Architectural Review Board Staff Report

Description: **Downtown Chesterfield, Lots 8 & 9 (SLCL Chesterfield Branch):** An Amended Site Development Section Plan, Landscape Plan, Lighting Plan, Architectural Elevations, and Architect’s Statement of Design for consolidated lots 8 and 9 located on a 4.25-acre tract of land southwest of the intersection of Chesterfield Parkway West and Burkhardt Place.

Re: Downtown Chesterfield Lots 8-9 SLCL Chesterfield Branch 2025 ASDSP

We are pleased to offer the following responses your Review comments dated May 8, 2025.

Figure 5: Longitudinal Section Looking North

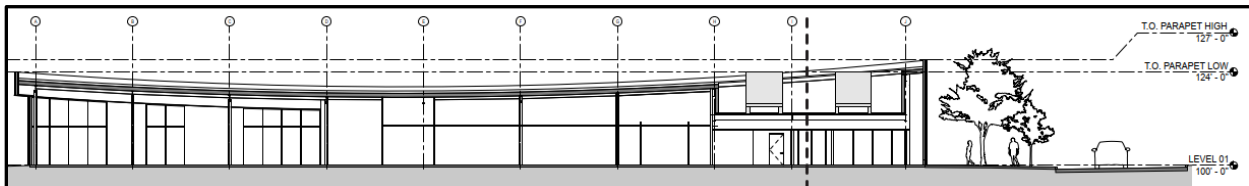
6. Please clarify the longitudinal Section Looking North. The parking area and roofline look as if you were facing the south elevation. Also, please label the rooftop mechanical equipment and confirm the rooftop mechanical equipment will be screened by the parapet.

Please see the illustrative site plan for overall section identifiers. The rooftop mechanical equipment has also been labeled and will be screened by the parapet.

DRAWING TITLE
 SITE LIGHTING
 PHOTOMETRIC PLAN

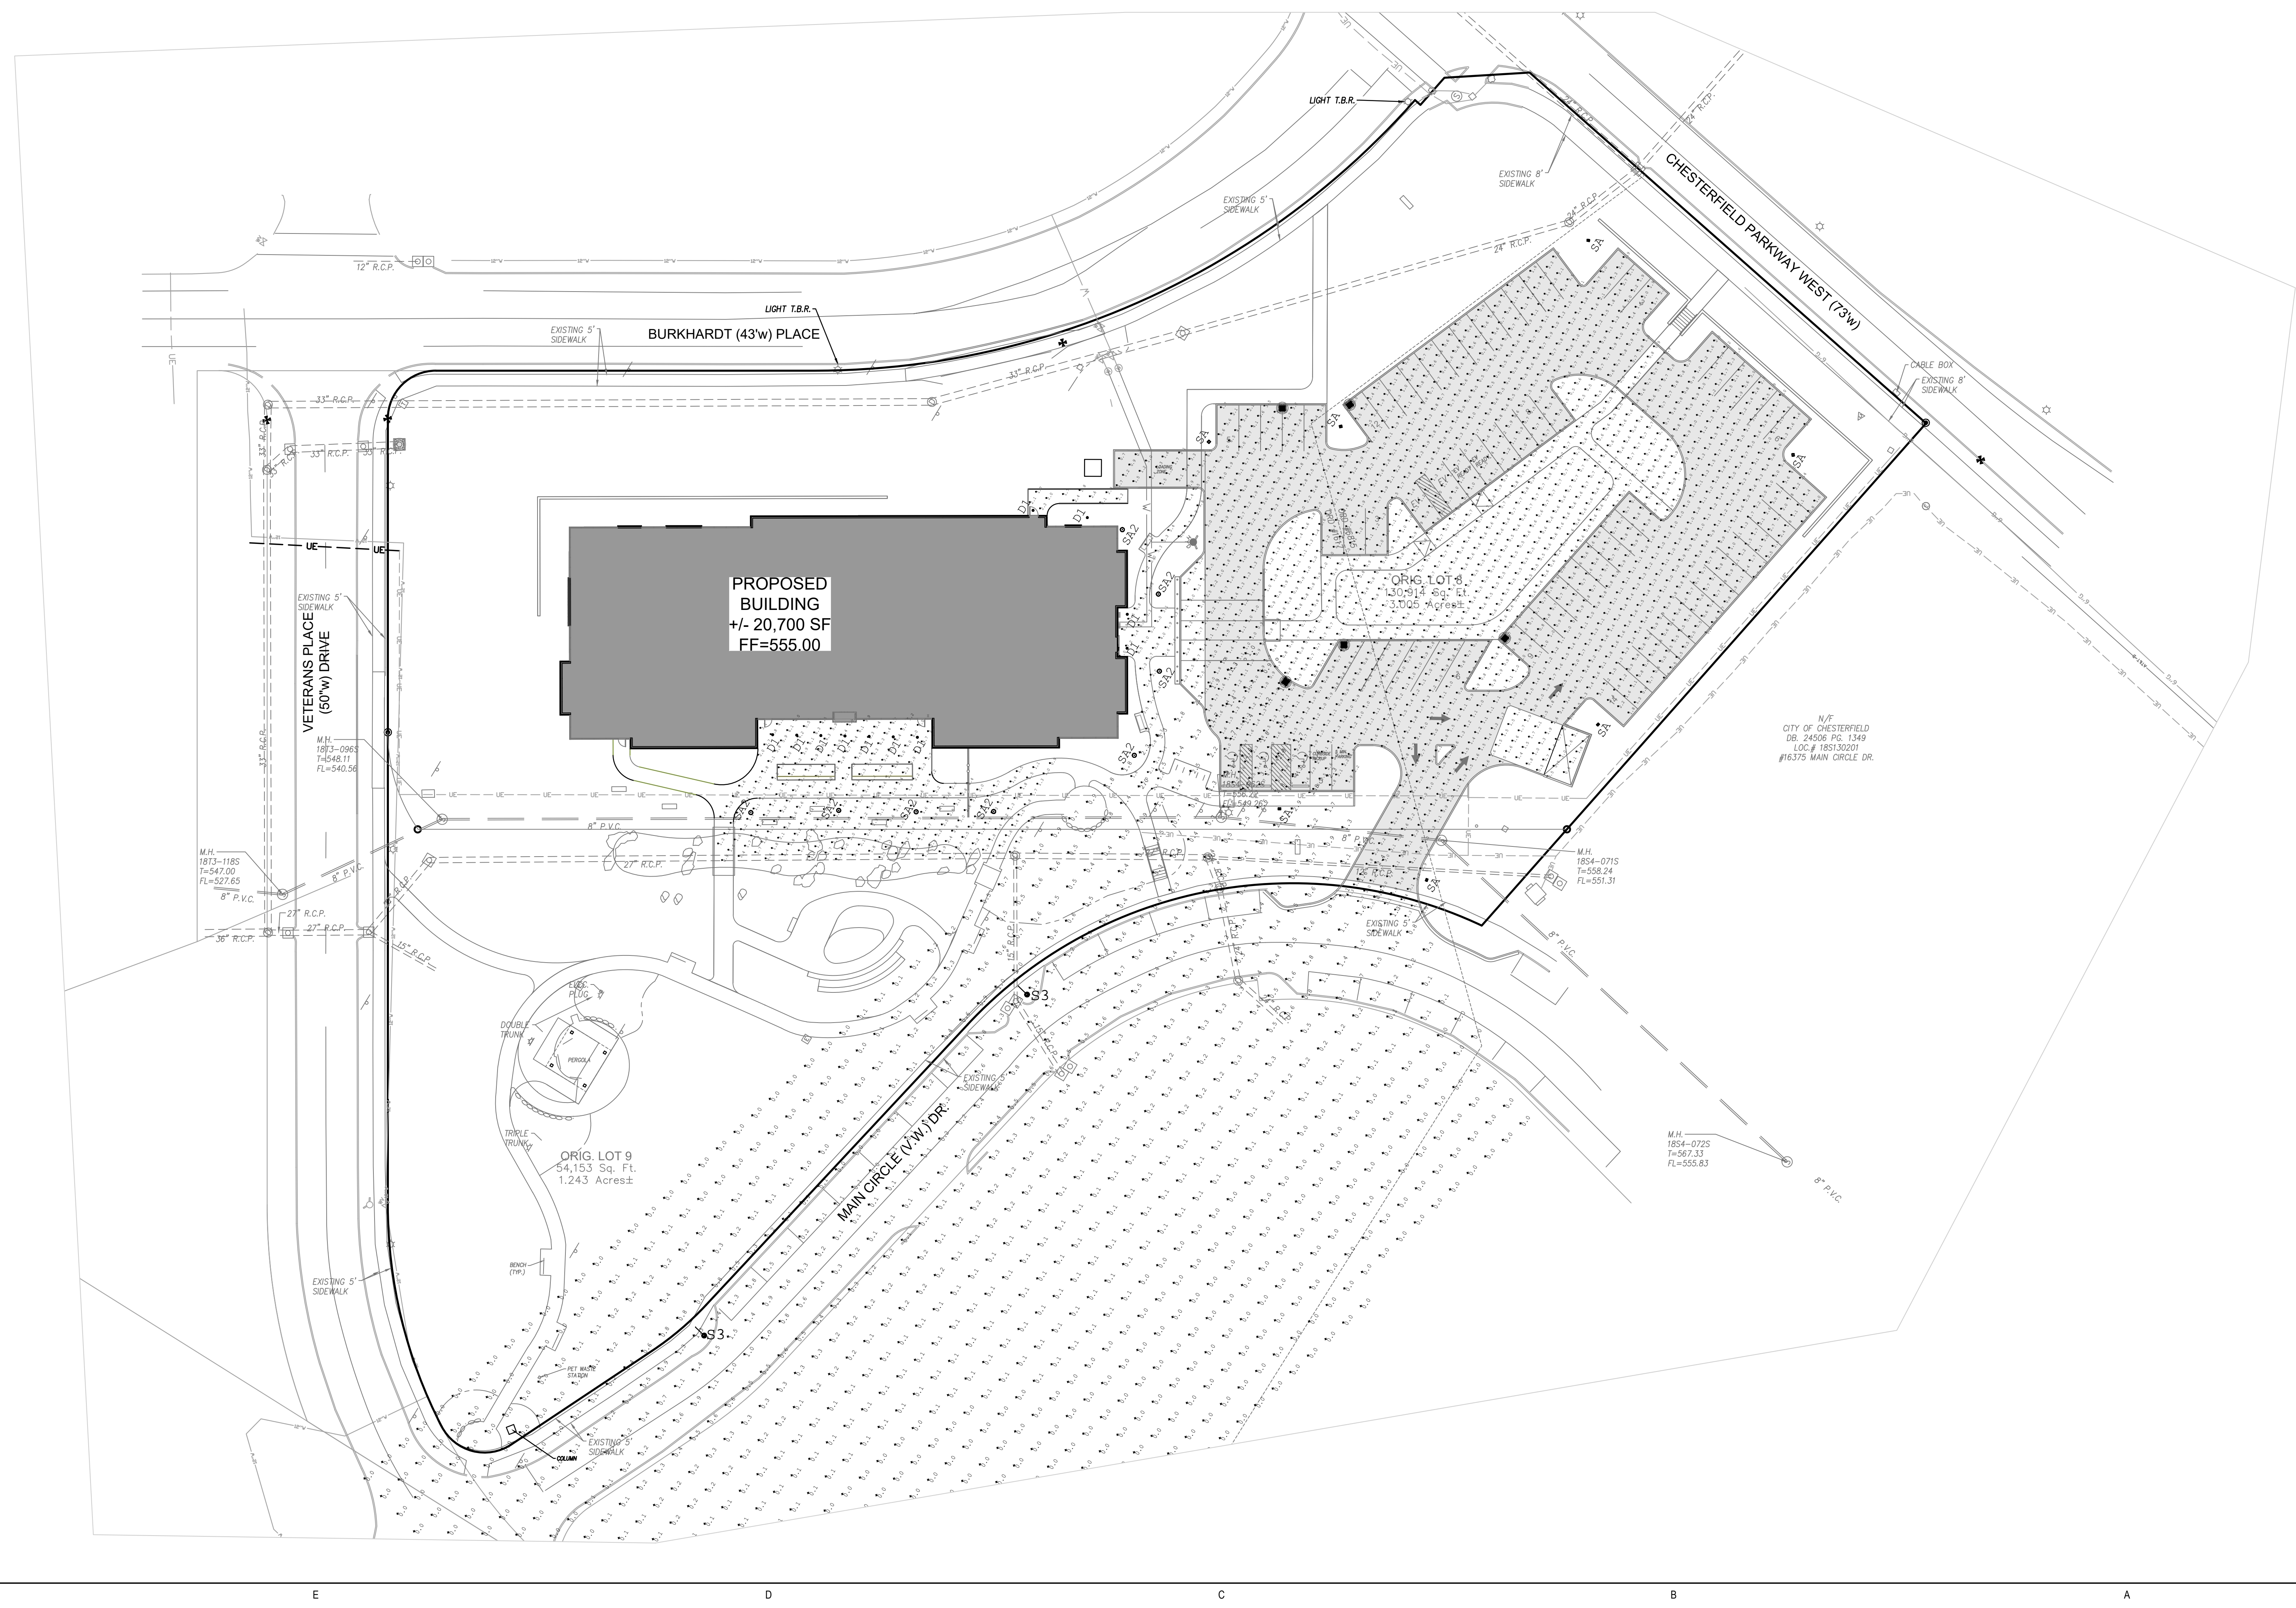
2. Please include the location of all existing and proposed exterior light poles and fixtures on the lighting plan.

The included updated civil plan now shows all the existing and proposed exterior light poles and fixtures. The following light fixtures will be included:

- *Lights to match existing Veterans Pl Dr fixtures*
- *Parking lot poles*
- *Pedestrian poles (at the entry and in the park)*
- *Building up lights*
- *Landscape up lights*
